State of California
AIR RESOURCES BOARD

CALIFORNIA EVAPORATIVE EMISSION STANDARDS AND TEST PROCEDURES FOR 2001 AND SUBSEQUENT MODEL MOTOR VEHICLES

Adopted: August 5, 1999
Amended: June 22, 2006
Amended: October 17, 2007
Amended: [insert amended date]

Note: Proposed amendments to this document are shown in underline to indicate additions and ~~strikeouts~~ to indicate deletions compared to the test procedures as last amended October 17, 2007. Existing intervening text that is not amended is indicated by a row of asterisks (* * * *).

Figure 3B: Test Procedure for 2001 and Subsequent Model Hybrid Electric Vehicles

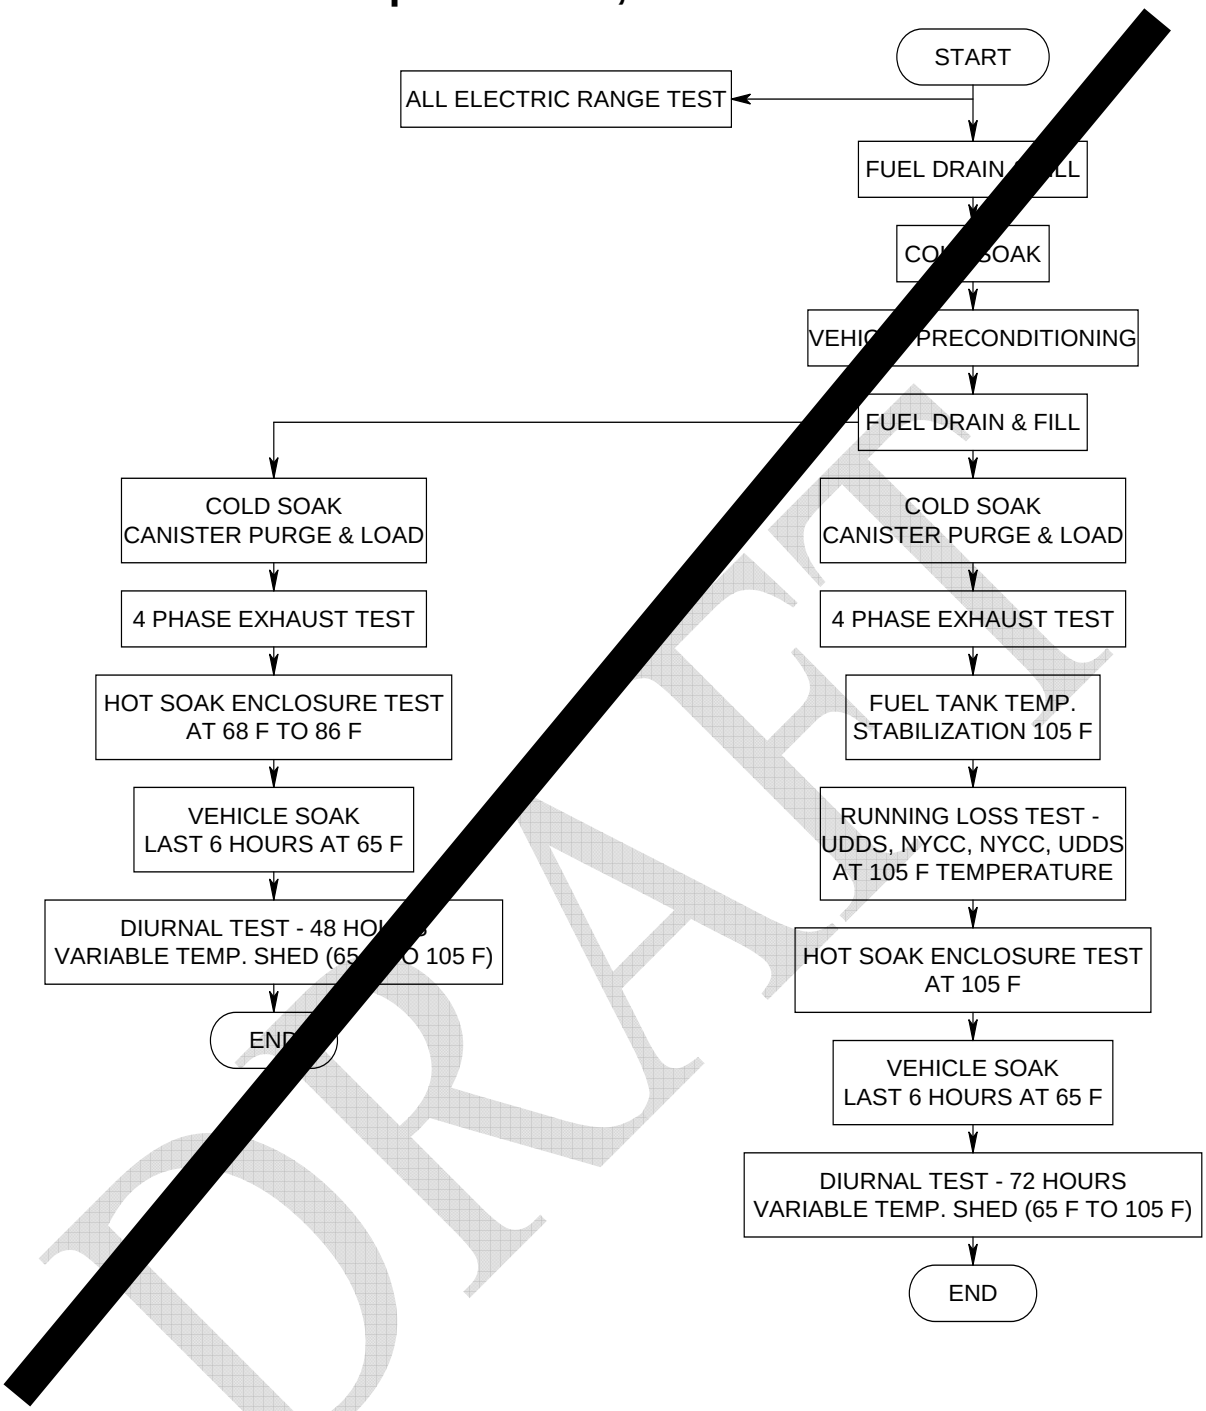
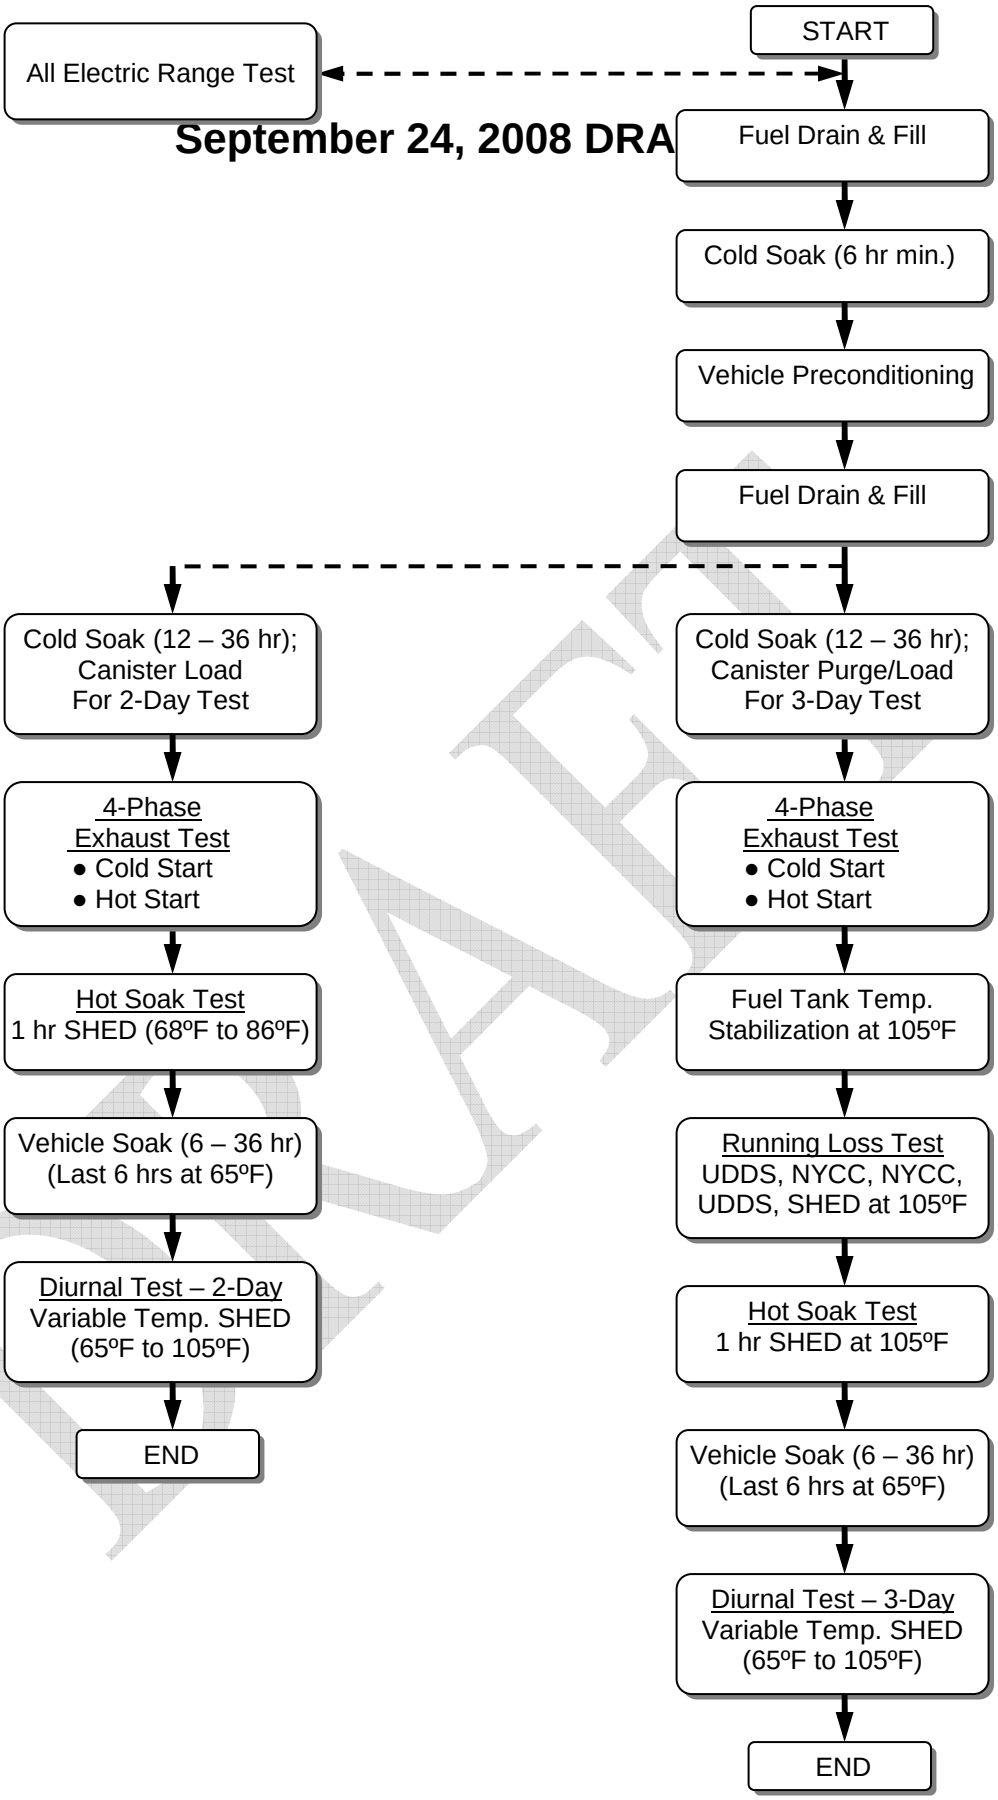
1.12.3. For 2001 through 2010 model-year hybrid electric vehicles, the four-phase exhaust testing may be performed in conjunction with evaporative testing, as shown in Figure 3B, with advance Executive Officer approval if the manufacturer is able to provide data demonstrating compliance with evaporative emission standards using the standard three-phase test.
